05 April 2023

AEMO Victorian Planning (AVP) and Transgrid

**RE: VNI West Consultation Report – Options Assessment (February 2023)
Non-confidential submission**

Figure 2 - Gippsland REZ - Step Change outcomes

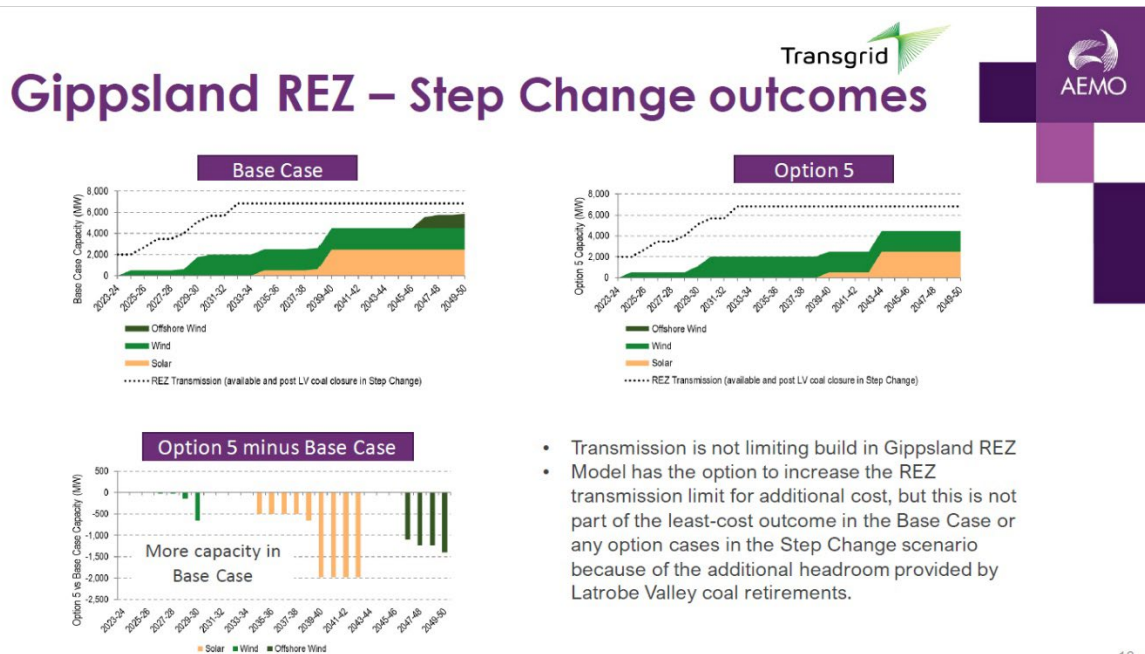
EGA is concerned that excluding Gippsland is the wrong choice for Victoria and the 2,000 MW build limit, based on land use constraints, has no meaningful foundation. There are great opportunities in Gippsland, with its strong transmission network.

The delayed timing of Gippsland investment, as a result of VNI West Option 5, does not align with the Victorian Governments objectives and does not align with local government objectives in the Latrobe Valley.

- Offshore wind is not developed off the Gippsland coast. This is despite the Victorian Governments clear commitment to offshore wind.
- Onshore wind is not developed in Gippsland, beyond the 2,000 MW hard build limit, until 2043-44, and in the base case until around 2039-40.
- Solar developments experiences similar constraints.

Figure 3 – Gippsland REZ - Step Change, offshore wind sensitivity outcomes

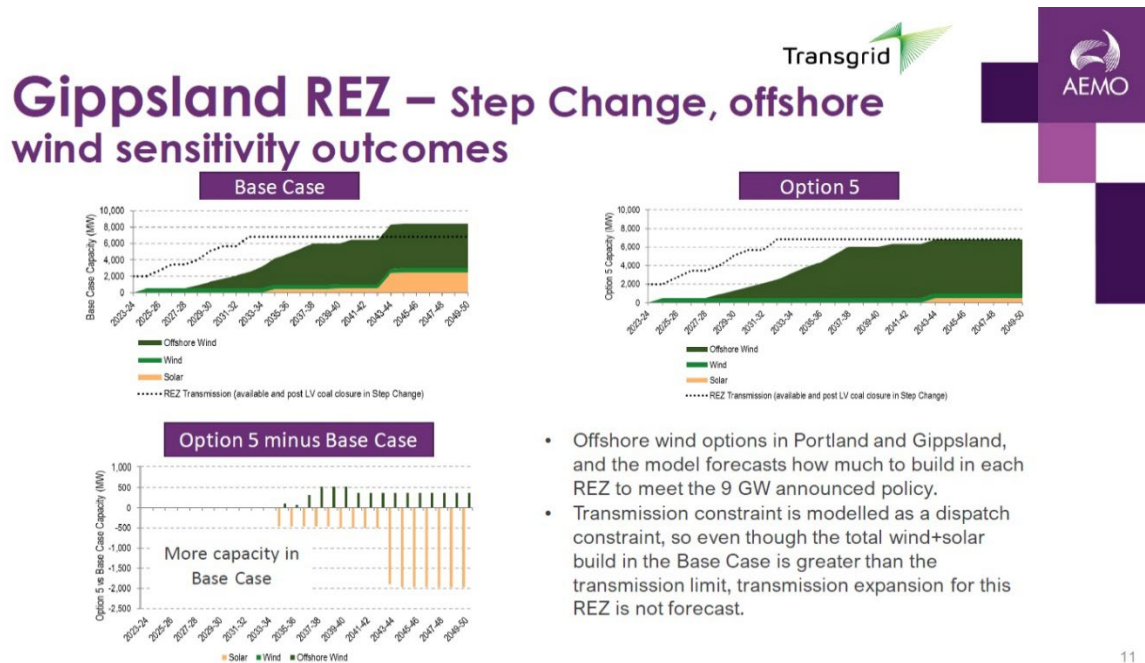
EGA cannot understand why the Gippsland region is not already being progressed when reliability and security of supply is so critically important to Victoria with coal fired plants closing towards the end of the decade?
